BUCKHORN BULLETIN

Okanogan Highlands Alliance

March 2008, Vol 2 No. 12

OHA Heads to Washington Water Court

Types of sequentially raised tailings dams

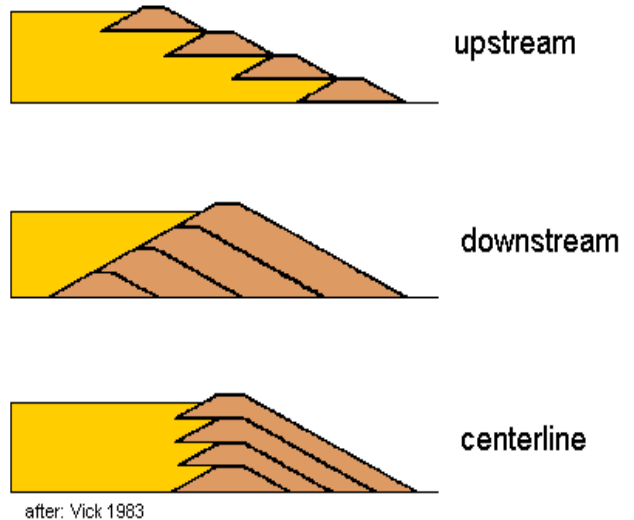
An upstream dam extension was approved for the Kettle tailings impoundment. This type of dam expansion is inherently risky and probably unsafe because of the assumptions made about the seismicity of the area and the stability of the tailings upon which the upstream dam extension will be built.

The primary concern with upstream tailings dam construction is its susceptibility to failure during earthquakes. If the tailings upon which the dam is constructed are saturated with water, the tailings do not form a stable foundation for the dam under seismic loading. Tailings are deposited in a saturated state. Tailings materials are relatively uniform in their size and shape, and typically have very low permeability, a fact often cited by mining industry engineers to argue that liners are not needed for tailings facilities. As a result, it is difficult to properly drain the water from all the tailings under the proposed dam expansion. For an upstream-type tailings dam, which uses the tailings themselves as a structural foundation for the dam, the tailings must be dewatered in order to safely support the dam under seismic loading.

Kettle TDF Construction-The TDF was constructed with three conventional downstream raises – Phases I - III. A fourth raise, Phase IV, was constructed using the upstream method.

TDF Seismic Risk Evaluation - The use of a lower number than the Maximum Credible Earthquake for peak ground accelerations calculations is of concern, especially in light of the type of dam construction being proposed, upstream type, which is the most susceptible to seismic risk.

Safe Construction Approach for the TDF - The Buckhorn DSEIS does not discuss the costs or technical feasibility of using a centerline or downstream extension of the existing TDF. An extension of this type could encapsulate the existing upstream Phase IV extension, and would probably provide greater long term dam stability than the existing dam configuration.
